TECHNICAL MEMORANDUM

To: Nevada Environmental Response Trust

Subject: Seep Well Field Bioremediation Treatability Study – Notification of Field Implementation Modification

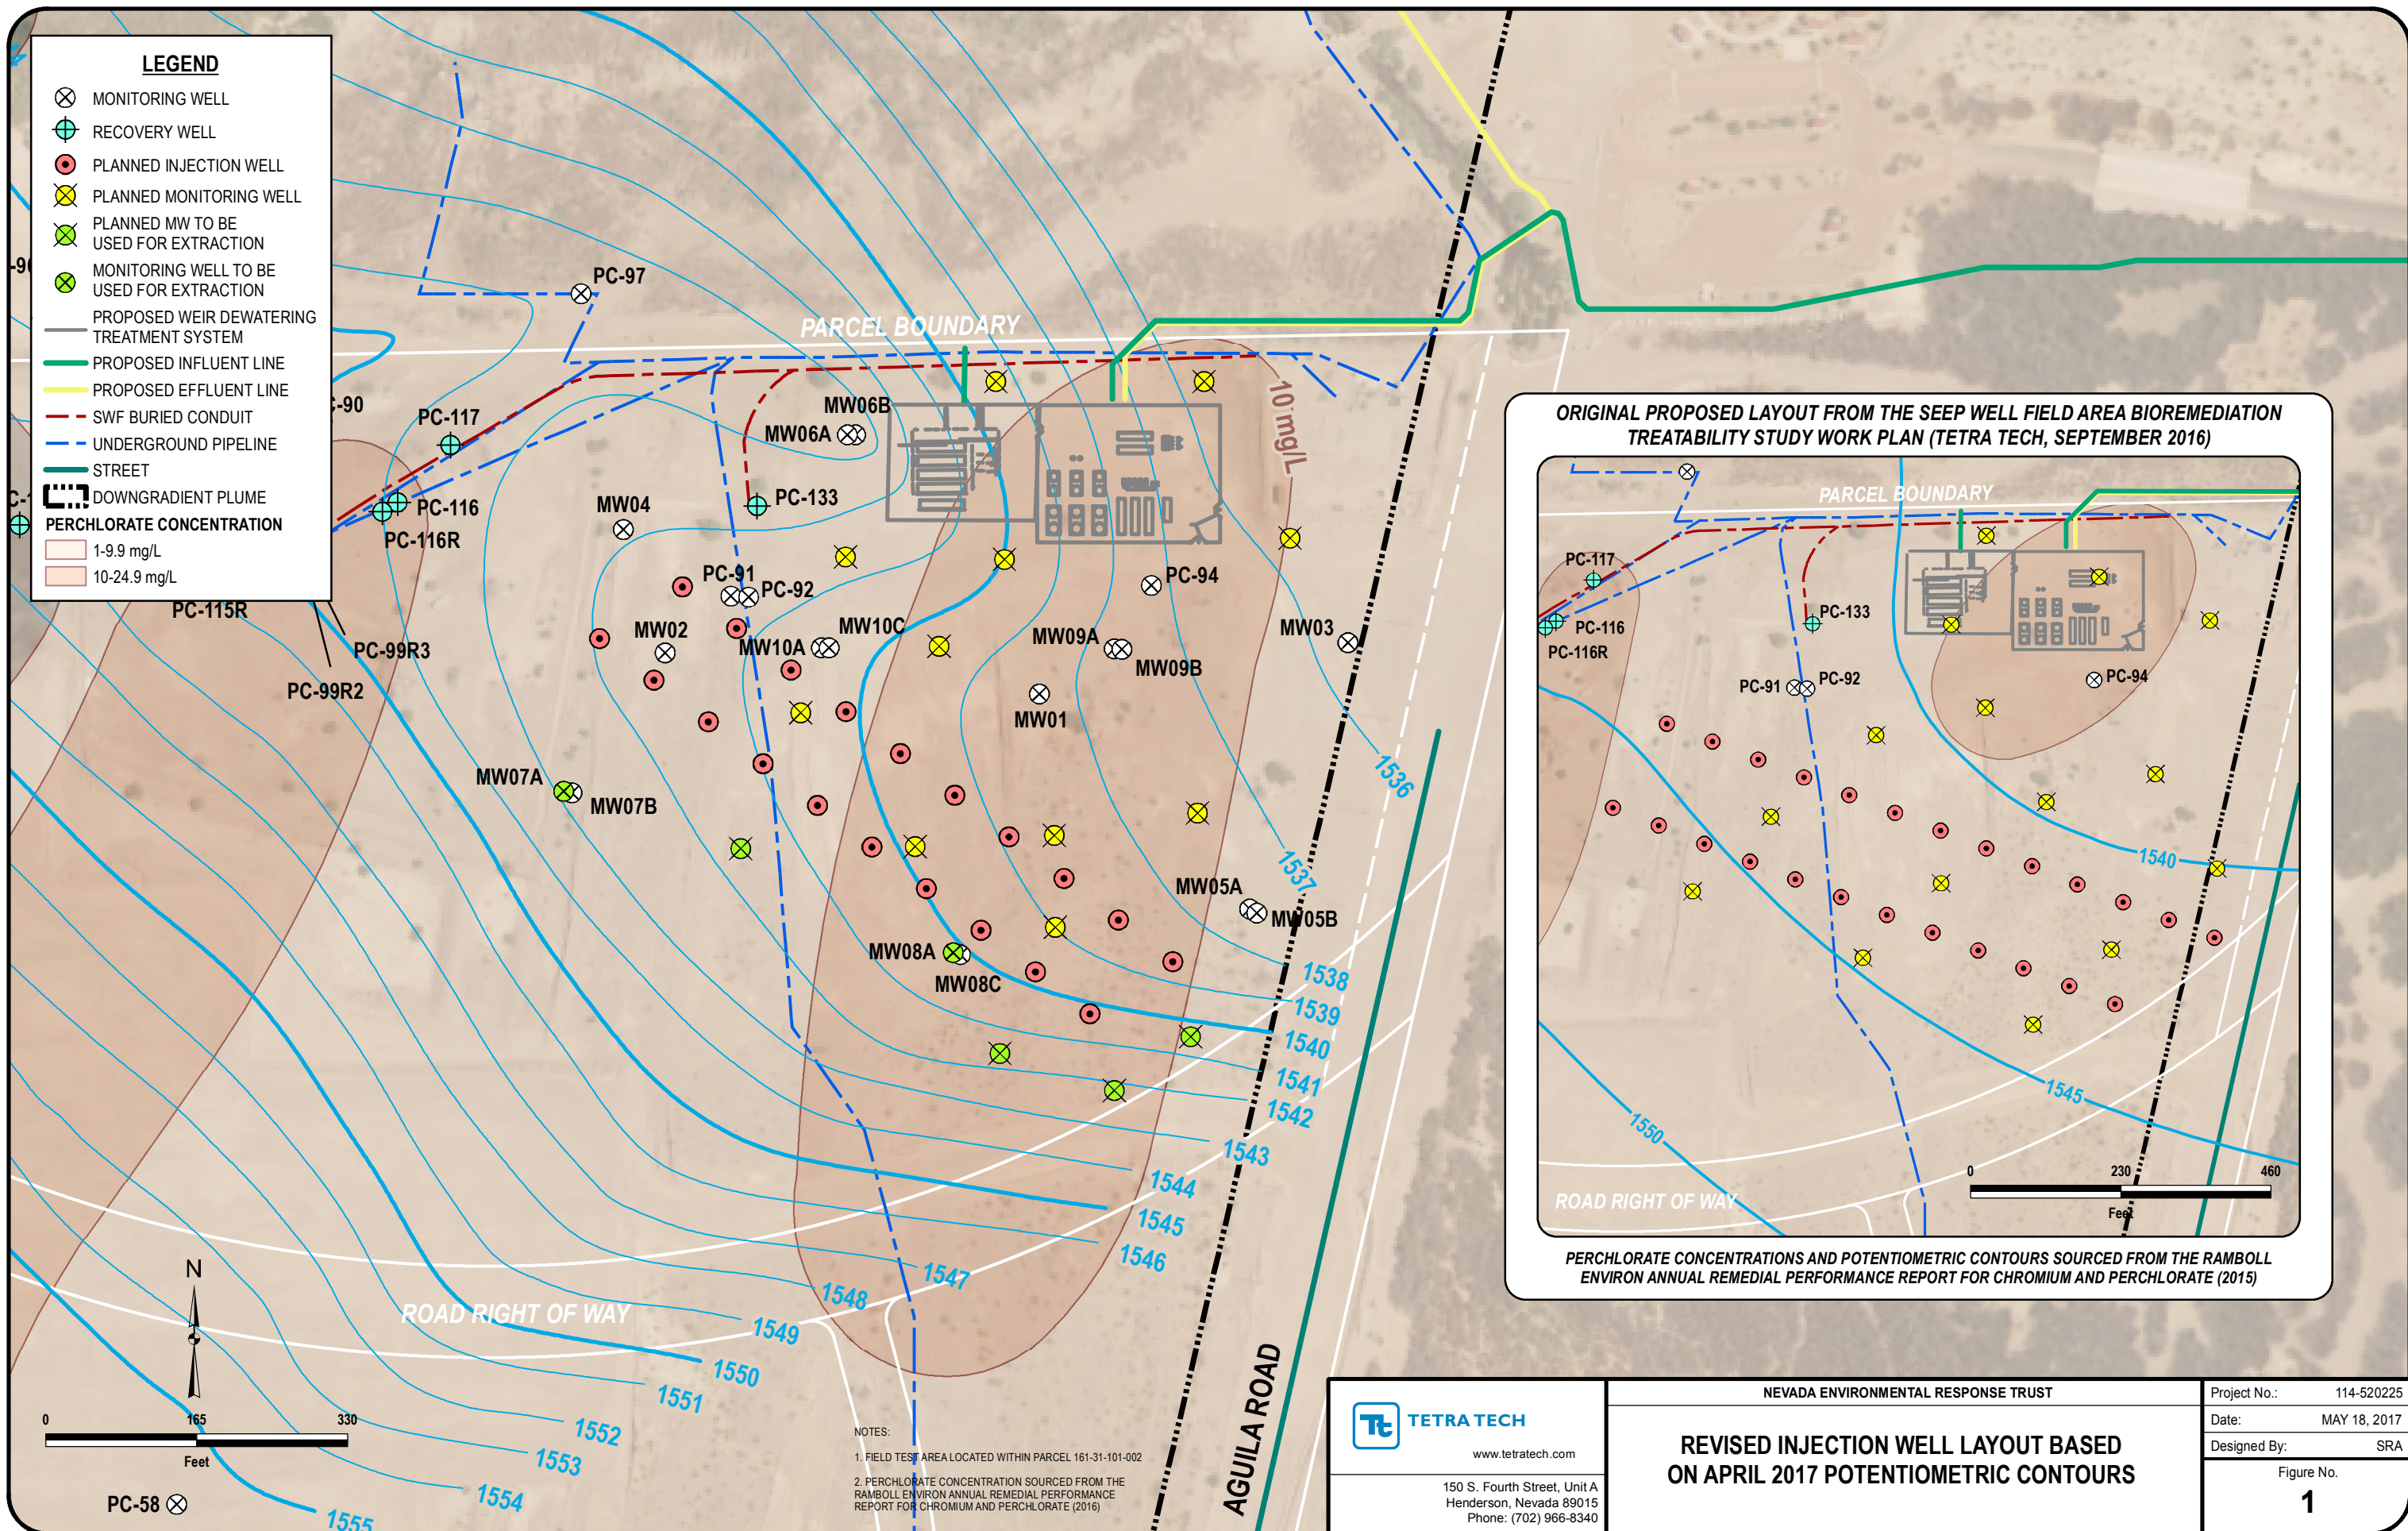
The Seep Well Field Area Bioremediation Treatability Study Work Plan presented a conceptual injection and monitoring well layout and states that the final quantity and location of the injection wells would be finalized after completion of the preliminary field activities. Tetra Tech recently completed several preliminary field activities, including geophysics, initial borehole and monitoring well installation, soil and groundwater sampling, and initial hydraulic testing. Based on these activities, additional potentiometric contouring was performed that revealed a slight shift from the previously presented potentiometric contours. As a result of this shift, Tetra Tech plans to slightly reposition the injection well transects to more appropriately intersect perchlorate-contaminated groundwater migrating towards the Las Vegas Wash. This reconfiguration of the flow regime results in the following:

- Approximate 15-degree rotation of the injection well transects;
- Shortens the length of transects (reduction from 25 to 20 injection wells, which is a reduction of two to three wells in each injection well transect) to remain within the access agreement boundary to the southeast and to minimize potential influence of substrate injection on the existing SWF extraction wells;
- Select injection well locations may still consist of paired wells to optimize carbon distribution (as stated in the Work Plan) with the need for paired wells based on field observations during drilling;
- Transect separation has been reduced from 150 feet to 100 feet following evaluation of soil analyses and results of borehole dilution and slug tests. Spacing between injection wells of 75 feet remains the same; and

- Monitoring well network adjusted accordingly to effectively monitor the treatability study based on the revised injection well layout.

The revised location of the injection well transects, monitoring wells, and updated potentiometric contouring is presented in Figure 1, which also contains an inset of the original conceptual design presented in the Work Plan for comparison purposes.

As explained in the work plan, distribution water is a key component of the injection process to promote an even subsurface distribution of the injectants within the injection well transects. This feature of the bioremediation design is important because it improves the distribution of the carbon donor laterally along the injection rows and creates a more complete treatment zone. Based on a review of the available water sources, Tetra Tech plans to utilize purge water from new and/or existing monitoring wells in the immediate vicinity of the treatability study injection wells for use as distribution water. Tetra Tech included this approach in the Underground Injection Control (UIC) permit application recently submitted to Nevada Division of Environmental Protection (NDEP) – Bureau of Water Pollution Control (BWPC). This is contingent upon NDEP – BWPC approval (via UIC permit issuance). If this provision of the permit application is not approved, Tetra Tech will use City of Henderson water. This process would be accomplished by extracting water from the nearby monitoring wells (screened in the alluvium) and transferring the water to on-site frac tanks for use during the injection process. Water extracted from these monitoring wells will be injected only within the barrier (also only in the alluvium) and will undergo the same level of treatment as the groundwater that flows past the barrier. Using the groundwater in this manner does not add contamination or relocate the groundwater outside of the current formation and general location. The number of monitoring wells used in this operation will be dependent on the final hydraulic properties of the wells and pumping rates that can be achieved. Based on initial hydraulic testing (borehole dilution and slug tests), it is anticipated that six monitoring wells may be needed for this operation. Locations of these wells are presented in Figure 1.
